TESTIMONY OF GREGORY KENT PRICE FOR  
THE LONG ISLAND LIGHTING COMPANY  
ON SUFFOLK COUNTY CONTENTION 5 --  
LOOSE PARTS MONITORING SYSTEM

## 8.0 ELECTRIC POWER

TABLE 8.1-2  
ELECTRICAL PENETRATION ASSEMBLY SHORT-CIRCUIT CAPABILITY

NUCLEAR SAFETY RELATED  
FSAR FIG. 8.1.2A

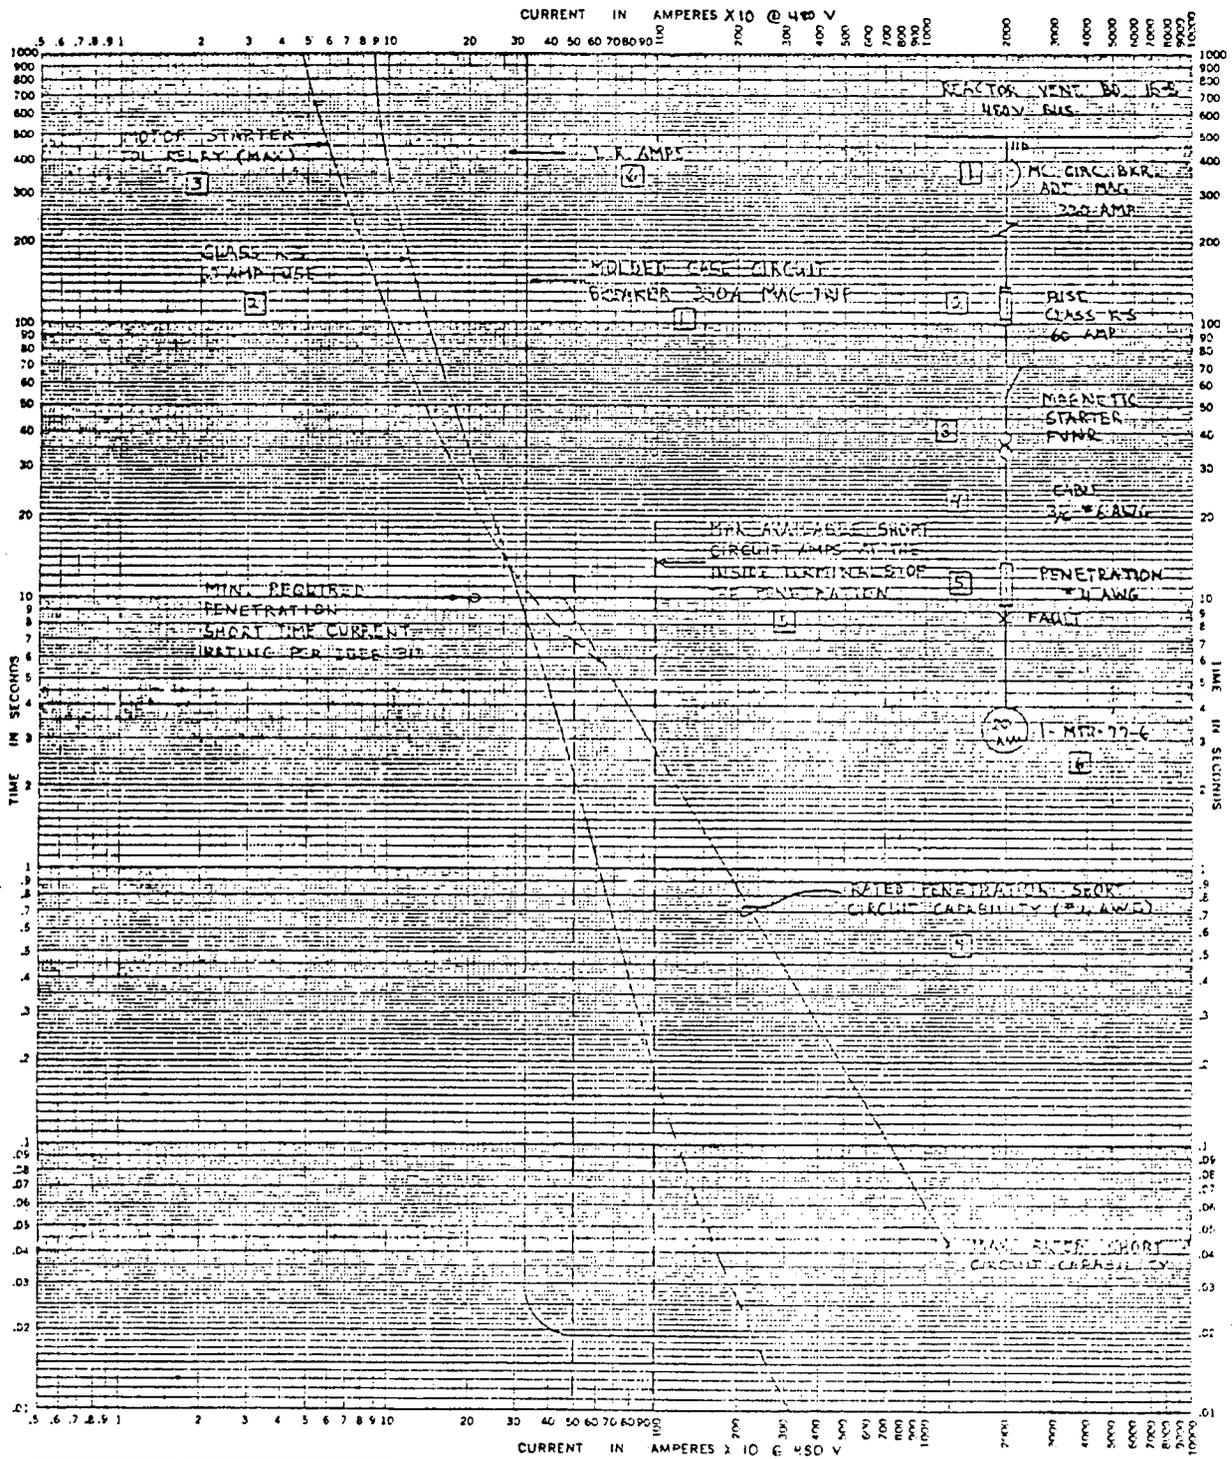
Replace revised Figure 8.1-2 shown in Amendment 44 with the same figure of the previous amendment since the revised figure shows the new fifth diesel generator which has not been formally presented to the NRC. This revised figure will be submitted with the appropriate SAR text at a later date.
